**RE:** PETITION NO. 1423 - Bloom Energy Corporation petition for a declaratory ruling, pursuant to Connecticut General Statutes §4-176 and §16-50k, for the proposed construction, maintenance and operation of a 150-kilowatt customer-side fuel cell facility and associated equipment to be located at the Home Depot, 90 Monroe Turnpike, Trumbull, Connecticut.

**Petition No. 1423**  
**Bloom Energy Corporation**  
**Home Depot, 90 Monroe Turnpike**  
**Trumbull, Connecticut**

**Interrogatories – Set I**

**OVERALL SITE PLAN**  
SCALE: 1" = 30'

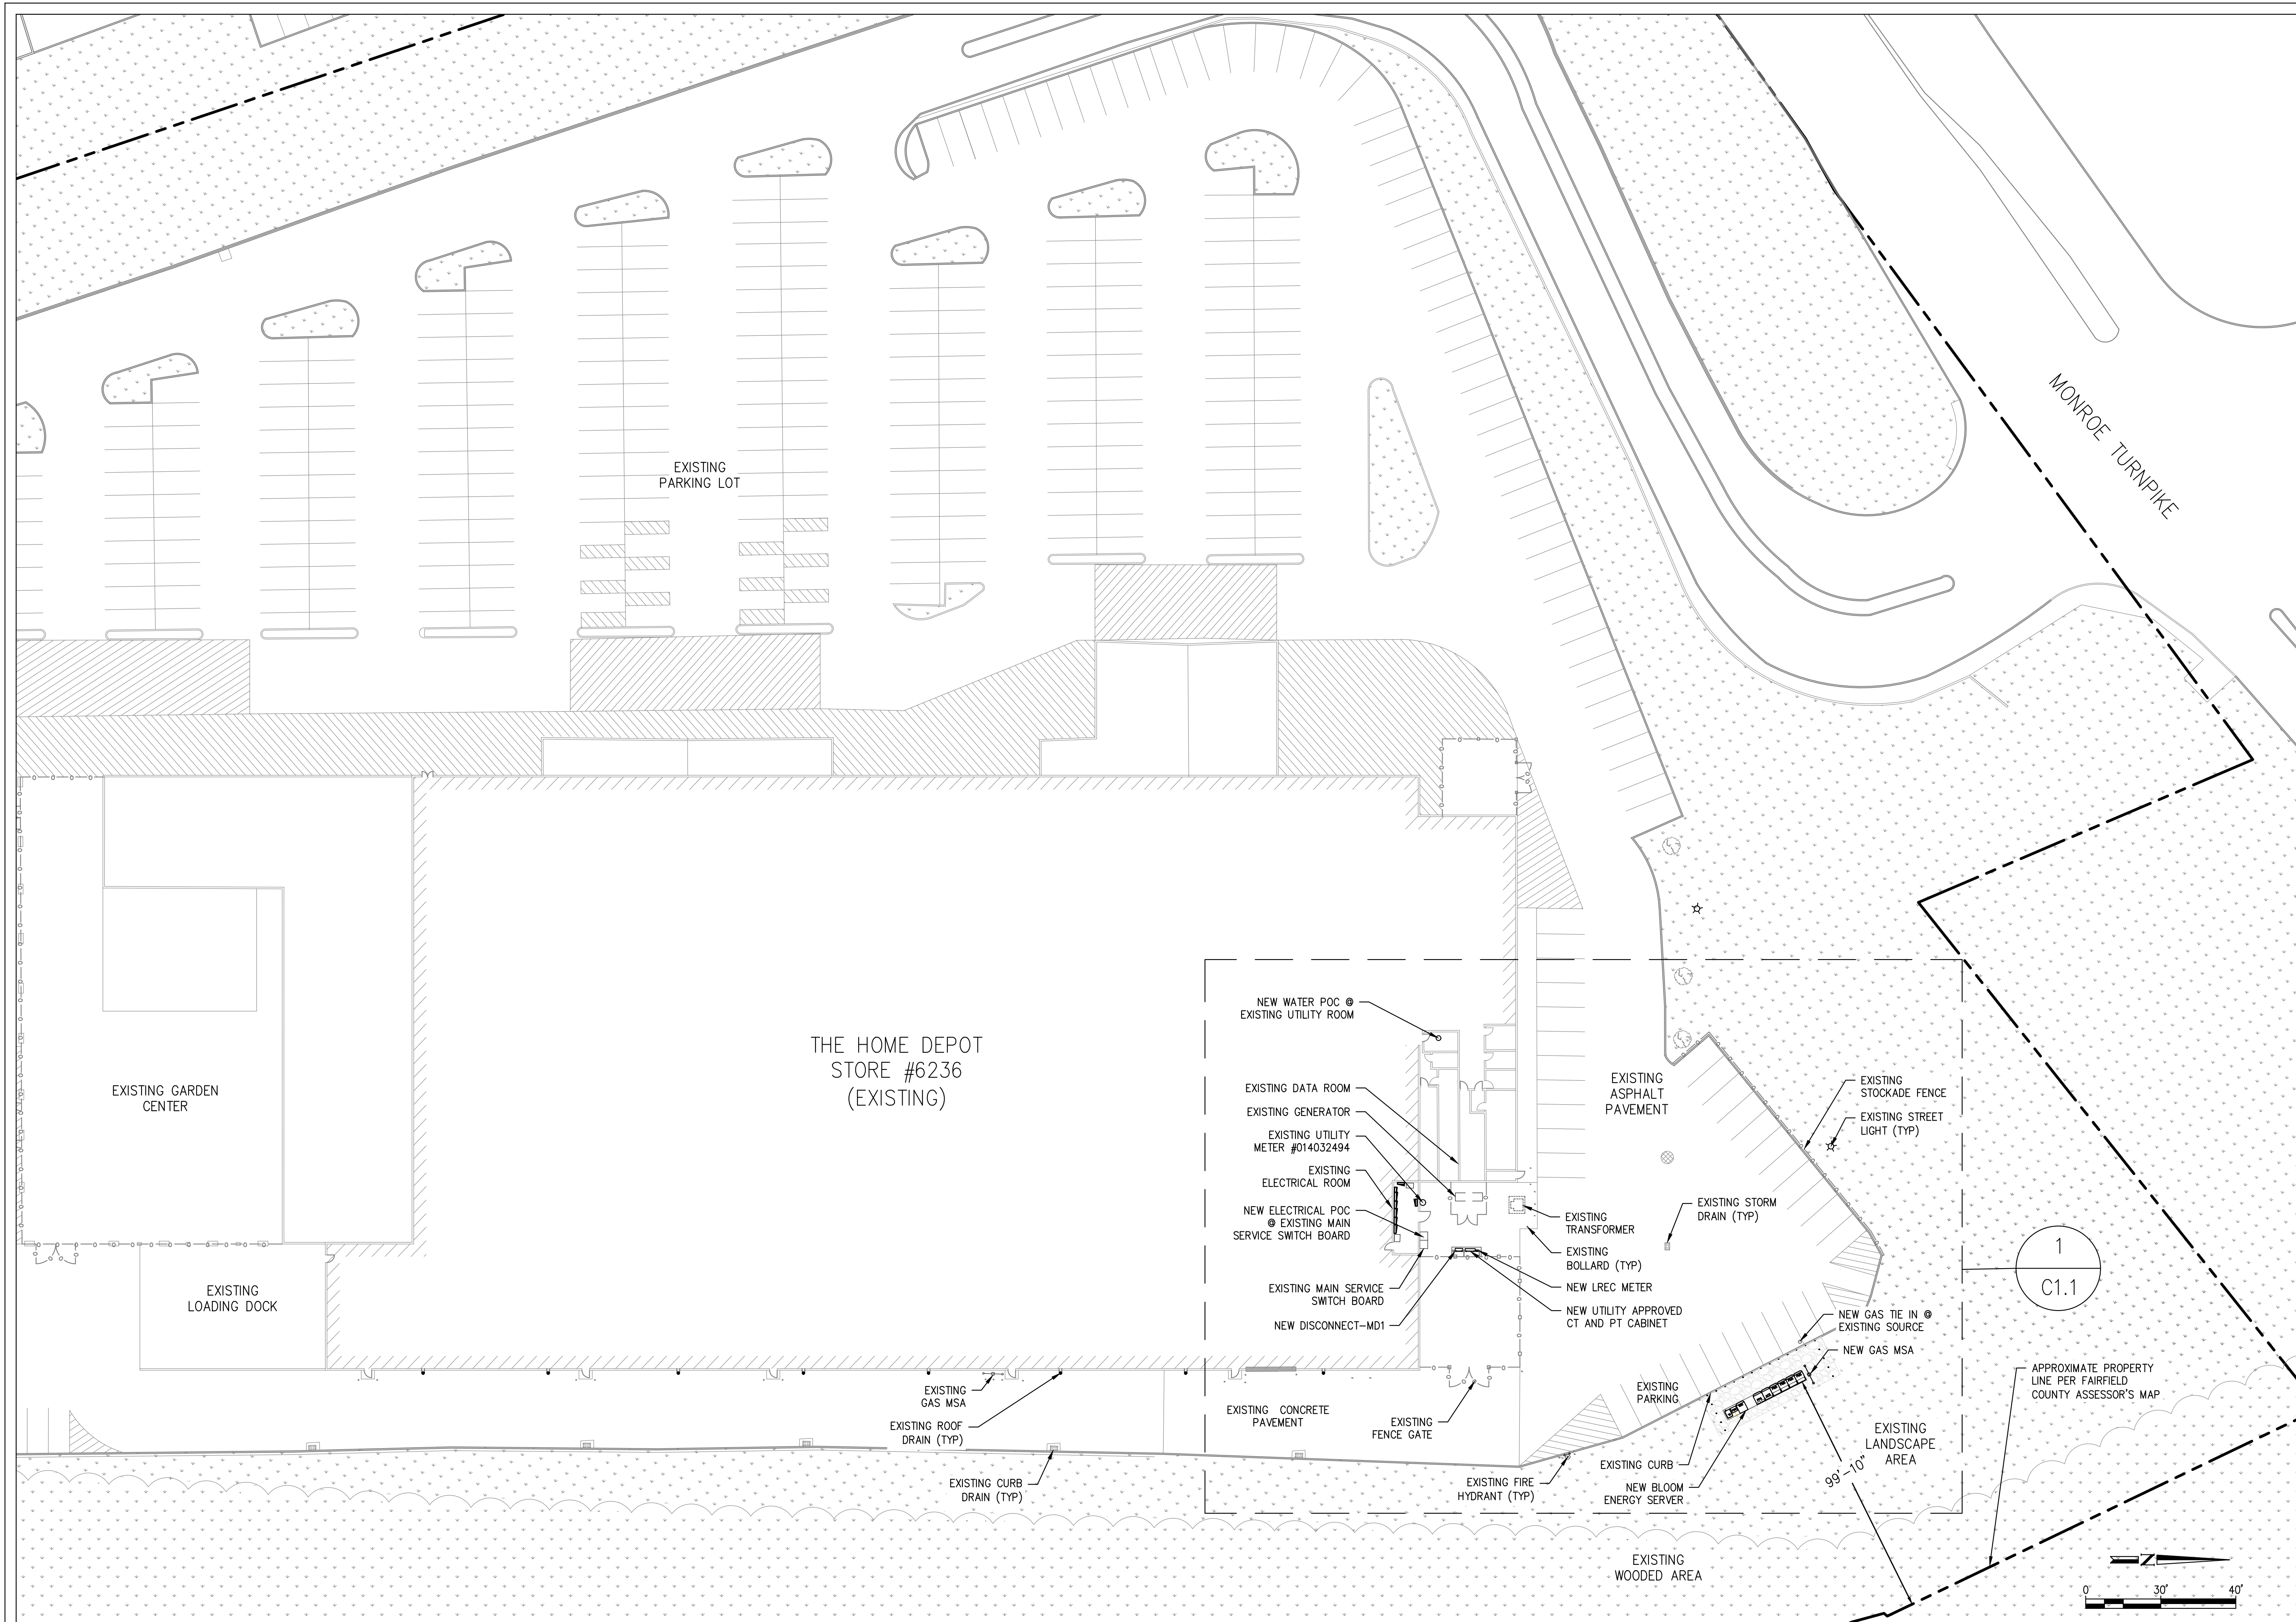
1. Please provide a detailed Site Plan of the proposed facility, including but not limited to, the dimensions and locations of the proposed fuel cell facility, concrete pads, cabinets, fence design, bollards (if applicable) and utility connections.

2. What is the distance of the proposed fuel cell facility to the Home Depot building?

**Response:** Please see the attached site plan with dimensions and locations of the proposed fuel cell facility, concrete pads, cabinets, fence design, bollards and utility connections.

**Response:** The proposed facility would be 124 feet from the existing building.
